ADDENDUM NO. 1

Re: Clinton Bristow Dining Facility Renovations

Alcorn State University Lorman, Mississippi Architect's Project No. 2103

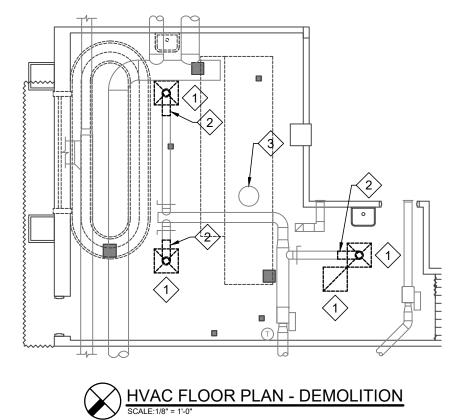
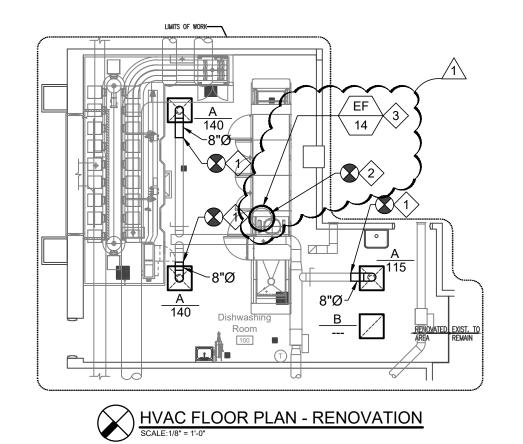
Item No. 5: See attached mechanical.

3. REMOVE EXISTING ROOF MOUNTED FAN. PROVIDE AND INSTALL NEW FAN ON EXISTING FAN ROOF CURB. PROVIDE ADAPTER CURB AS REQUIRED TO MOUNT NEW FAN ON EXISTING ROOF CURB. RECONNECT NEW FAN TO EXISTING POWER AND DUCTWORK. COORDINATE ALL CONNECTION LOCATION IN FIELD.

POWE	R VENTILA	TOR SCH	HEDL	JLE										
•	TAG	MANUFACTURER AND MODEL NO.	TYPE	PE CFM ESP RPM SOUND ELECTRICAL ON/OFF INTERLOCK OP WT (LBS) REMARKS		REMARKS	}								
	EF 14	GREENHECK CUBE-120	ROOF MOUNTED	750	0.25	843	5.5	1/4 115/1 DISHWASHER SWITCH CONTROLS 100 PRE-WIRED DISCONNECT, BACK DRAFT DAMPER, ADAPTER CURB] }
